**SUBJECT: NRC ACCEPTED VERSION OF IMPROVED BPWS CONTROL ROD INSERTION
PROCESS LTR, NEDO-33091-A**

**NEDO-33091-A
Revision 2
Class I
DRF 0000-0008-3745
July 2004**

Improved BPWS Control Rod Insertion Process

**SUBJECT: SAFETY EVALUATION FOR LICENSING TOPICAL REPORT (LTR)
NEDO-33091, "IMPROVED BPWS CONTROL ROD INSERTION PROCESS"
(TAC NO. MB9642)**

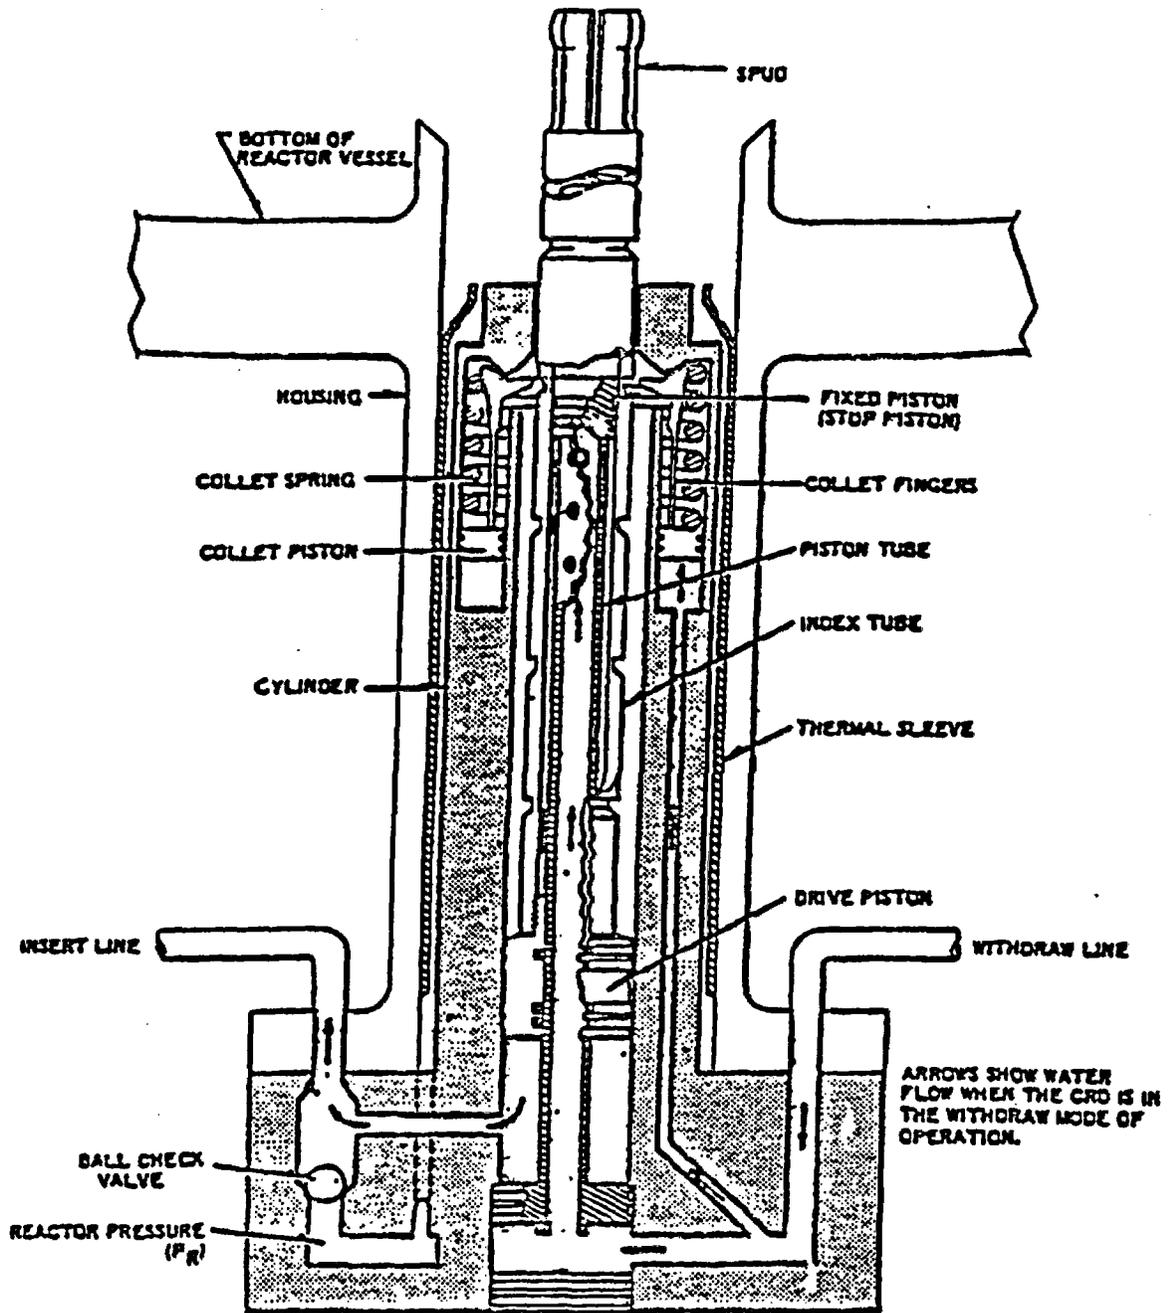
1. The LTR states that it is impossible for a control rod to become decoupled during the shutdown process following the improved BPWS. Please provide detailed information about the different types of control rod drives (CRDs) used for BWR-2 to BWR-6 plants with respect to the coupling between the CRD and control rod during shut-down. Based on this information, please also explain why it is not possible for the CRD and control rod to be decoupled.

All Reg. Guide 1.70, Rev.3 BWR UFSARs contain failure mode and effects analyses (FMEA) for the CRD system. Attachment 1 includes some pages from the FMEA in a typical BWR UFSAR (i.e., Limerick). As stated in the last paragraph of page 4.6-18, no single failure can of itself initiate a rod withdrawal. This statement is even more applicable, when the collet fingers are locked, such as when there is no CR movement or the CR is being inserted. (See Limerick Figure 4.6-3.) For a CR to withdraw, the six collet fingers must be unlocked so that the index tube can be lowered without being latched to a stop by the collet fingers. During CR insertion, if a mechanical/hydraulic failure occurs that stops all upward hydraulic force, the most the CR could withdraw is 6 inches to the next index tube latching indentation.

Attachment 1 also provides the UFSAR Control Rod Drive (CRD) and Control Rod (CR) design figures for a BWR/2 (Oyster Creek), BWR/3 (Monticello), BWR/4 (Limerick), BWR/5 (La Salle) and BWR/6 (Perry). For all BWR/2-6 plants, these figures demonstrate that a CR sits atop its associated CRD, and that it is physically impossible for a CR to move down past (i.e., to be withdrawn) its CRD.

Normally, a CR cannot become uncoupled from its CRD, because the CRD spud (“6-fingers”) mechanically locks into the CR socket, and operator action is required to unlock this coupling. It is possible, due to a CRD assembly error, for a CRD to not properly lock into CR. In this case, CR movement (withdrawal and insertion) and scram are not impaired, because gravitational force will maintain the CR on top of its CRD. Plant Technical Specifications already provide provisions for coupling checks and steps to be taken if a CR is uncoupled from its drive.

FIGURE 4.6-3

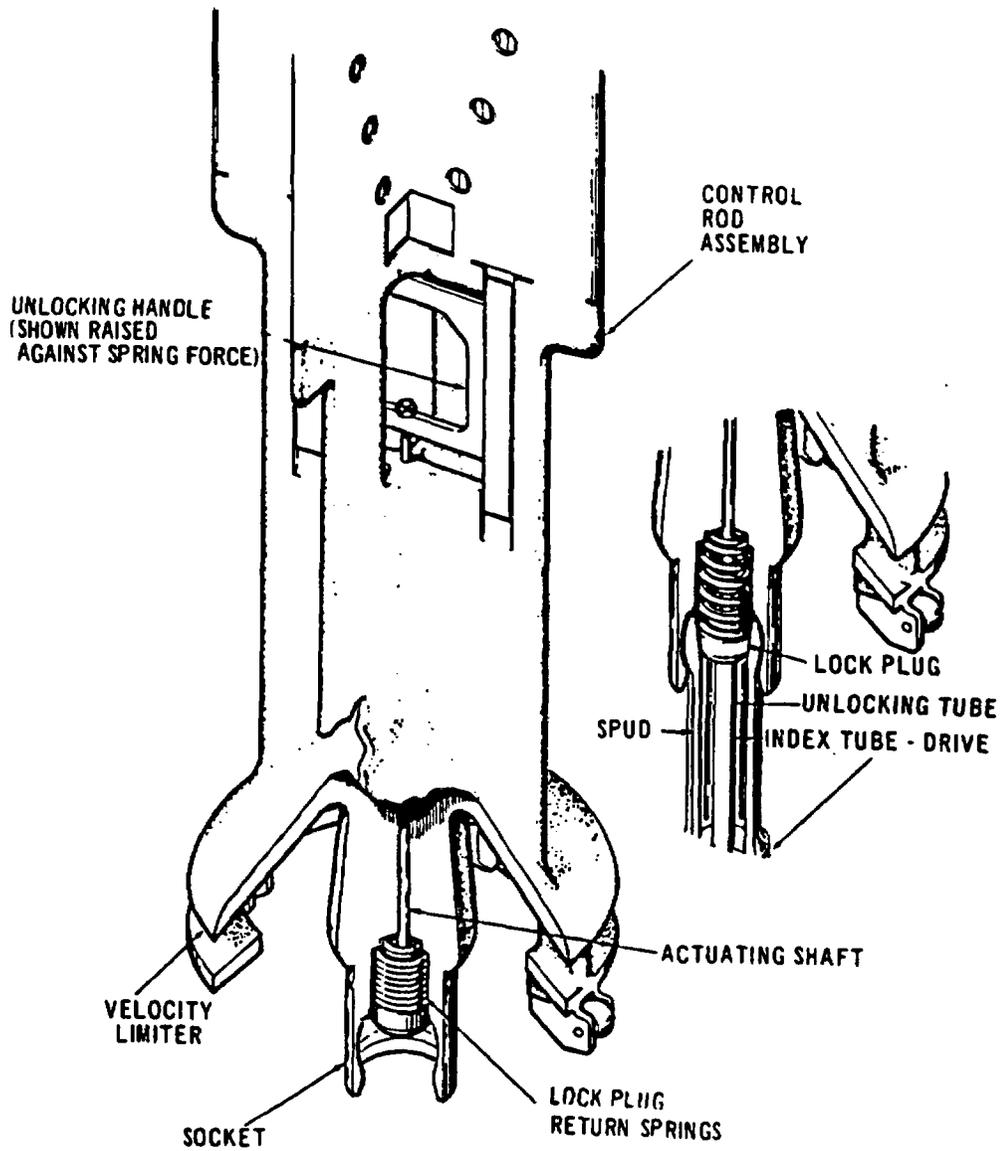
Rod withdrawal is, by design, more involved than insertion. The collet fingers (latch) must be raised to reach the unlocked position (Figure 4.6-3). The notches in the index tube and the collet fingers are shaped so that the downward force on the index tube holds the collet fingers in place. The index tube must be lifted before the collet fingers can be released. This is done by opening the drive insert valves (in the manner described in the preceding paragraph) for approximately one second. The withdraw valves are then opened, applying driving pressure above the drive piston, and opening the area below the piston to the exhaust header. Pressure is simultaneously applied to the collet piston. As the piston raises, the collet fingers are cammed outward, away from the index tube, by the guide cap.
